Electronic Delivery
October 24, 2023

**Re: Additional Comments on Farm Road Homes -
Evaluation of Revised Stormwater Management Plan
Farm Road Homes 40B Development Project
55-65 Farm Road
Sherborn, MA**

**Reproductions of Expert Report
dated September 27, 2022**

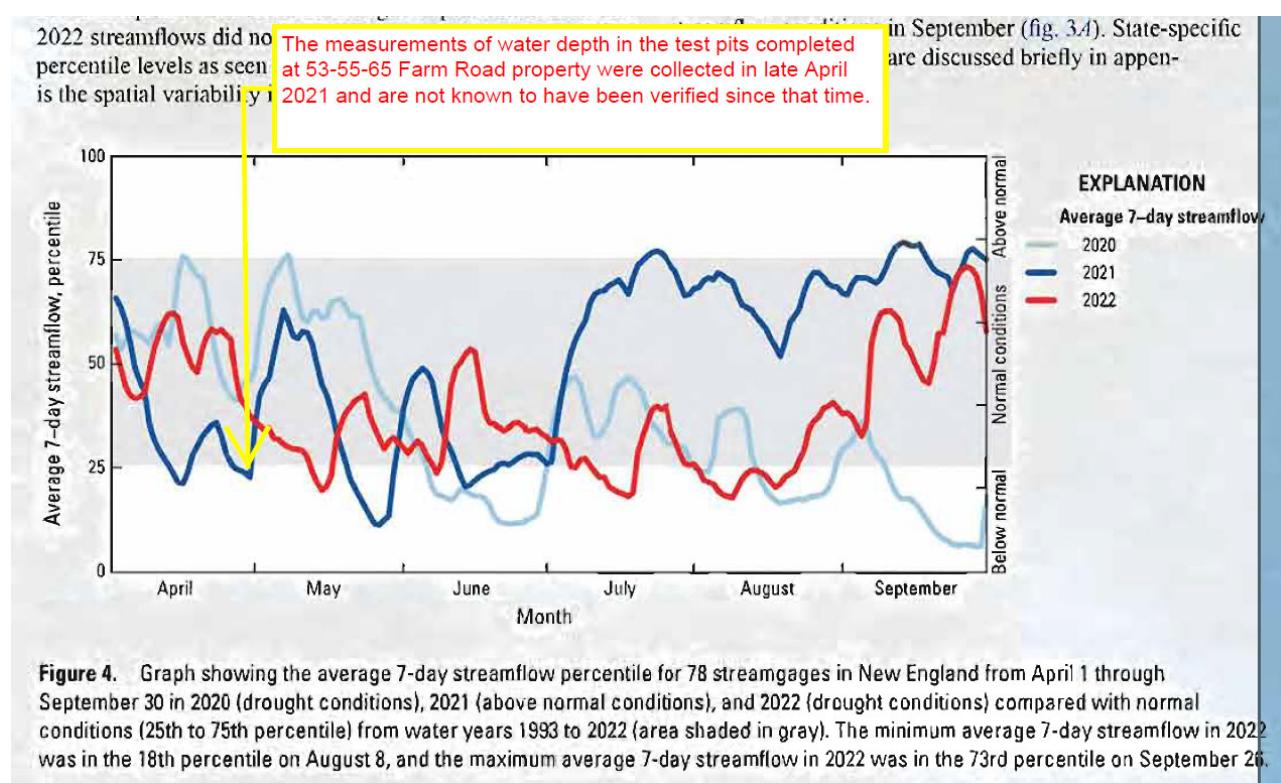
Another potential cause for concern is the fact that the Applicant’s original soil plan and test pit work was conducted in April 2021 at a time of historically-low streamflow conditions seen across New England - a time period that likely represented some of the lowest recorded groundwater elevations in the last 30+ years. We are including here a graphical representation of historical streamflow averages as compiled and presented by the United States Geological Survey (USGS) as a means to demonstrate that those values should not be considered reliable for the purpose of design and permitting a new septic system for the Farm Road Homes 40B project:

Figure 1 - Area of Impact - Lots 1 - 4

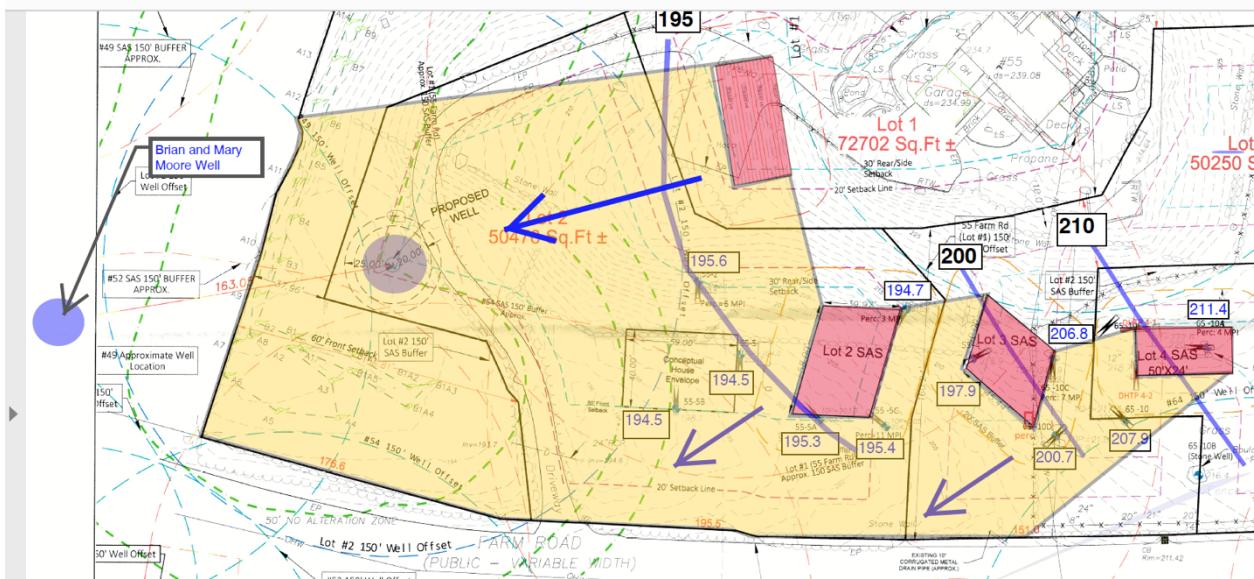
Based upon these groundwater flow directions I delineated two Areas of Impact (AOI). These include the AOI for lots 1, 2, 3, and 4 (see figure 1) and another AOI for the 40B Conceptual Overlay Plan prepared by Creative Land Development dated April 26, 2022 (see figure 2).

I then calculated the resulting nitrogen concentrations at the downgradient property boundary with your parcel (see Table 1). This analysis indicates that the proposed

wastewater discharges will result in nitrate-nitrogen concentrations in excess of the drinking water standard of 10 mg/liter at the property boundary and on your land. This analysis is conservative in that it does not account for fertilizer applications and stormwater runoff losses.
